## PLANNING COMMITTEE – THURSDAY 22<sup>nd</sup> February 2024

**22/1764/FUL - Demolition of existing building and erection of retail food store, (Use Class E(a)), with associated access, parking and amenities at World Of Water, Hempstead Road, Watford, Hertfordshire, WD4 8QG**

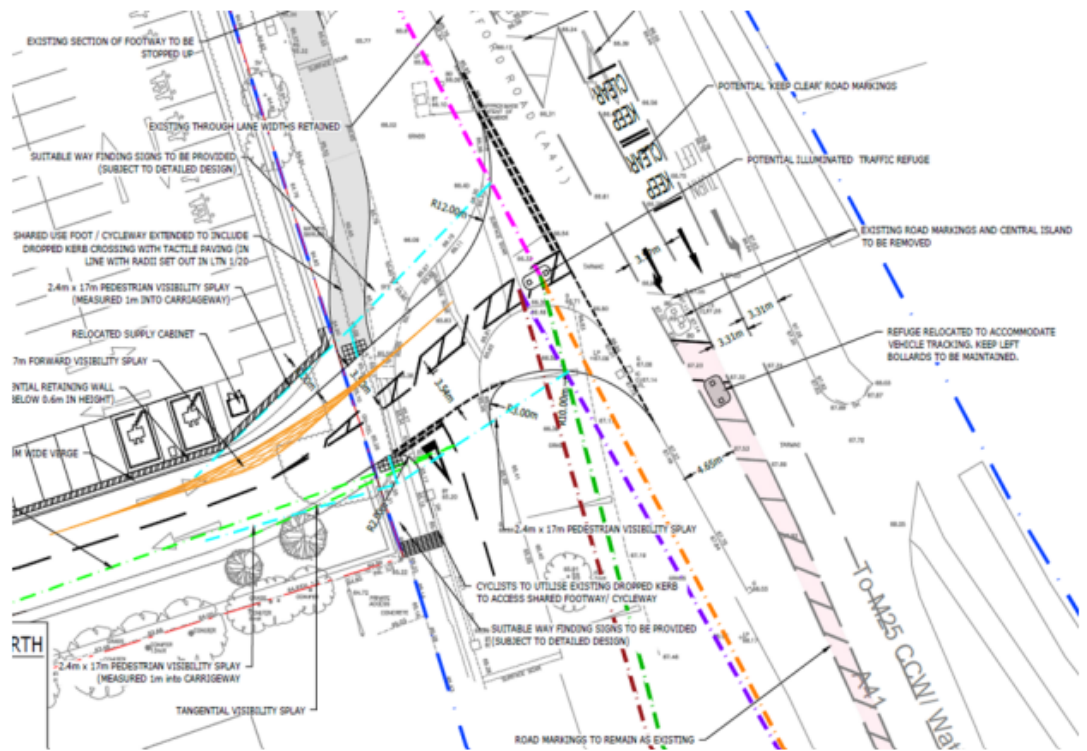
The site is presently accessed from a large priority junction which provides access to the World of Water aquatic centre, an adjoining café and military goods store and dwellings.

The above access presents a number of engineering challenges with the proposed foodstore usage to which the applicant's transport consultant has responded to, subsequent to comments made by the Highway Authority. This has included comments on visibility (both horizontal and vertical), vehicular access for large vehicles, geometry and turning into the site from both directions.

The Highway Authority has noted that safe and suitable access will need to be provided for goods vehicles servicing the proposed foodstore, that satisfactory visibility is ensured (in particular towards Hunton Bridge) and active travel is promoted.

Satisfactory access will also need to be maintained to the businesses/dwellings that are currently served from the service road.

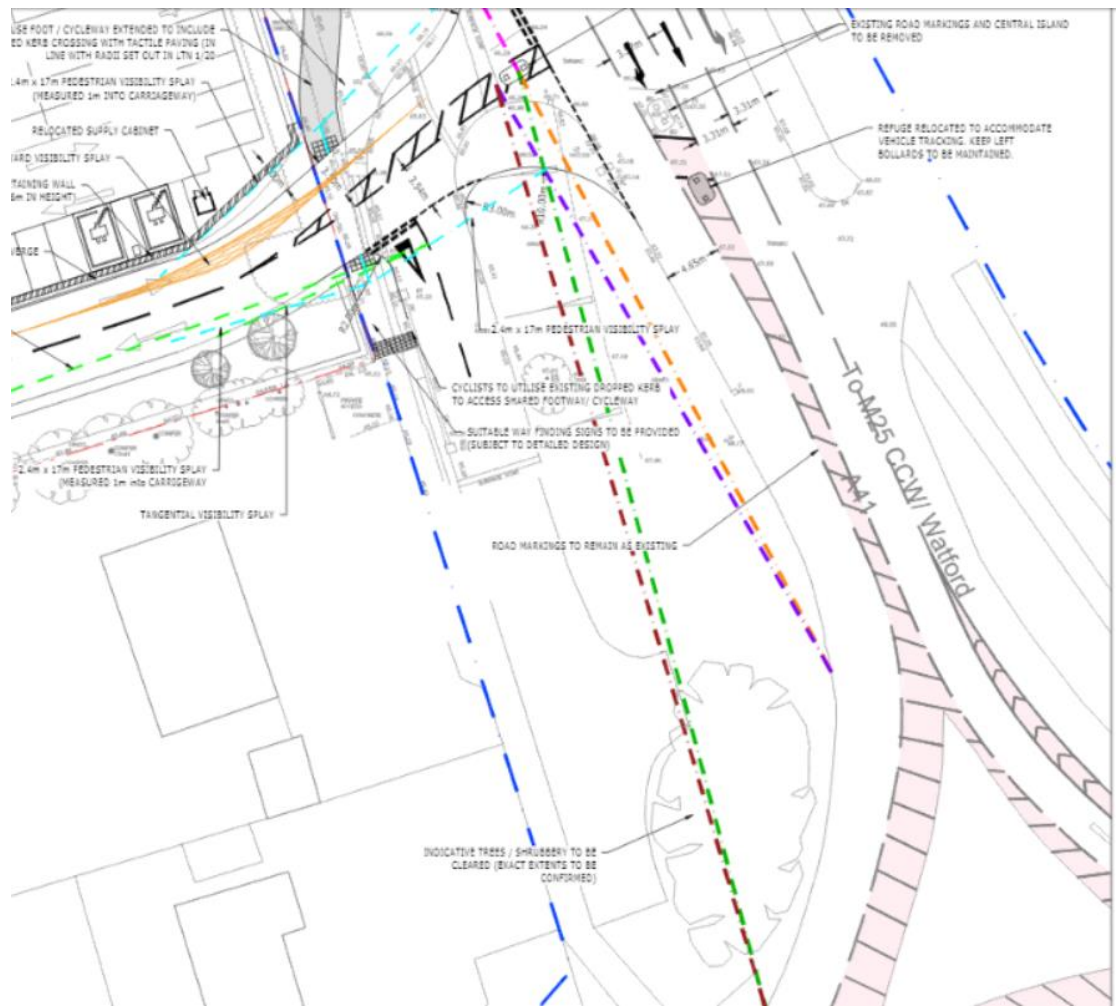
The Transport Assessment documentation is considered to satisfactorily present that the development may be accommodated on the local highway network in vehicle capacity terms.

The Highway Authority note the substantial change to the existing access arrangement to the World of Water site and adjoining service road which will require a Section 278 and completion prior to the first use of the development. The Highway Authority note also the relocation of the existing uncontrolled pedestrian crossing and improvements to the walking and cycling routes in the immediate vicinity of the site.

In summary, the Highway Authority does not wish to restrict the grant of planning permission subject to the aforementioned planning conditions and Advisory Notes.
